COMAL COUNTY

Permit of Authorization to Construct an On-Site Sewage Facility Permit Valid For One Year From Date Issued

Permit Number: 117889
Issued This Date: 01/10/2025
This permit is hereby given to: Braker Dessau LLC

Subject: Review Comment Response: Septic System Design for 7-Eleven Store # 40570;
14580 River Road, New Braunfels, TX;
Permit # 117889

SHEET C511

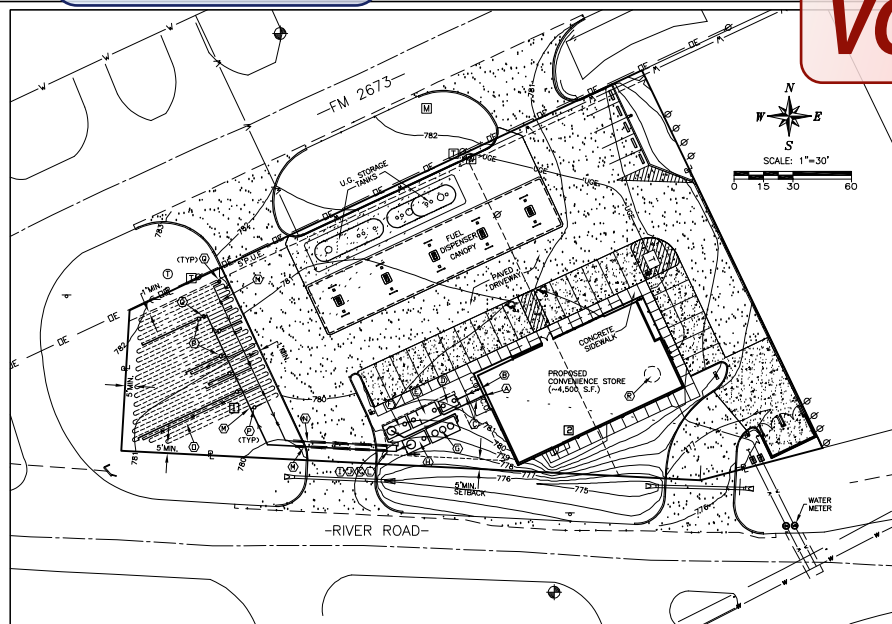
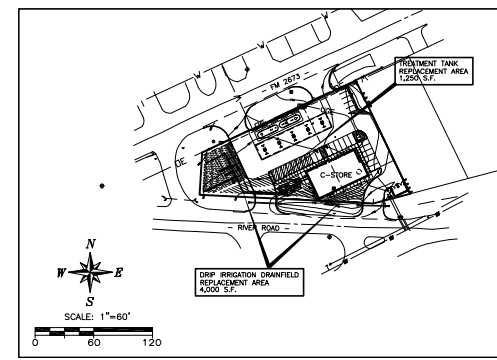
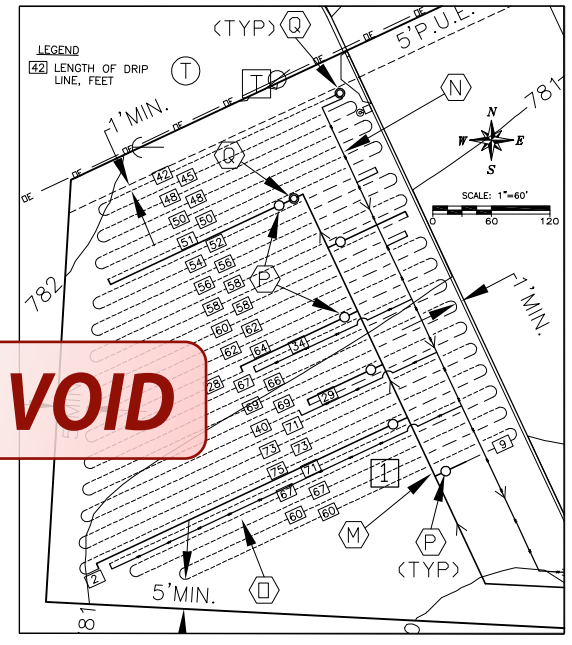
Please find attached the revised OSSF plan sheets which include an added drip field detail showing lengths of the individual drip lines as requested in your review comment #3. Kevin S. from Dimension Group responded previously to your other comments.

C512

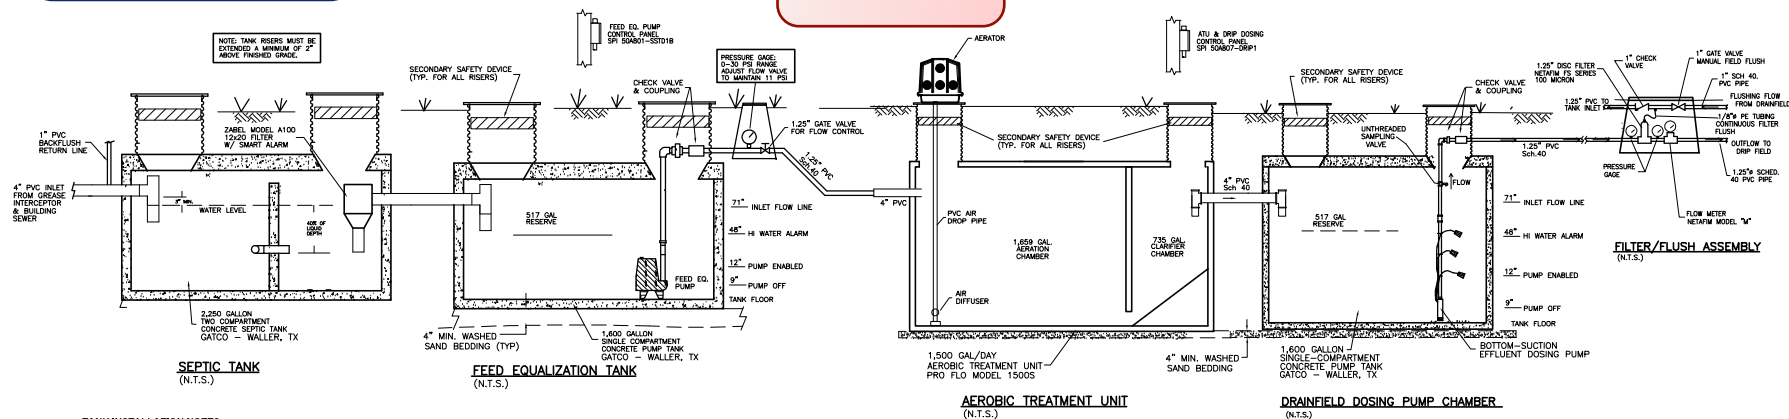
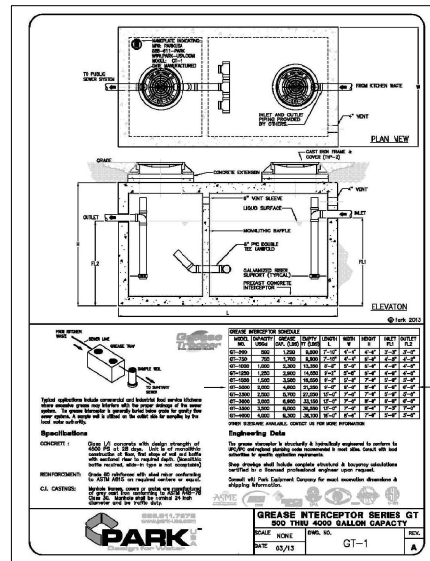
2. The Owner has been made aware of the issues regard public access to the treatment tank area. Appropriate measures are under consideration.
3. The out-dated verbage in the tank installation notes on plan sheet C512 has been removed as requested.
